10-Clutch Piston

GM Powerglide[®]

28765-05

10-Clutch Piston

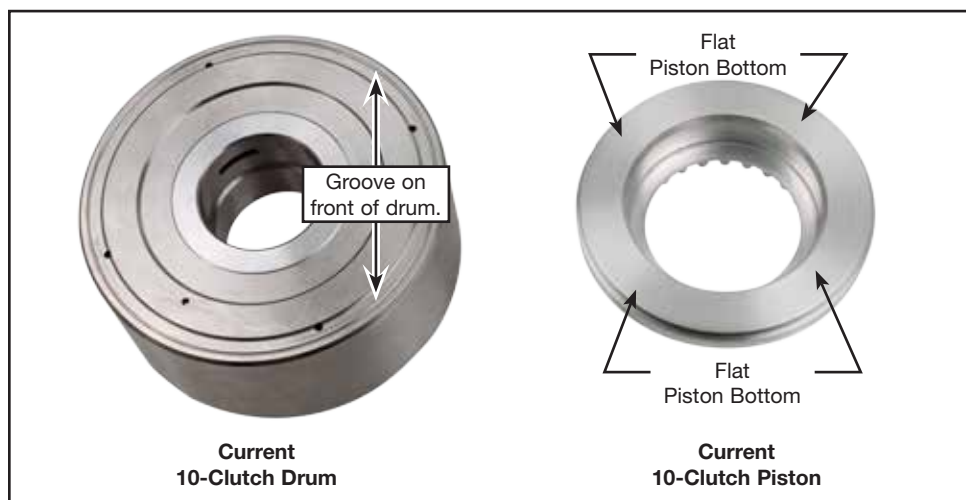
Sonnax 10-clutch piston **28765-05** is machined specifically for use with Sonnax 10-clutch drums **28756-01** and **28756-08**. These drums feature a piston bore that is .060" deeper for greater piston travel than was available from 10-clutch drums **28755-01** and **28755-08** (discontinued). These discontinued drums were specifically for use with Sonnax 10-clutch piston **28765-04** (also discontinued).

Sonnax 10-clutch pistons and drums should **ONLY** be used as matched parts. Use the images below to properly identify your parts.
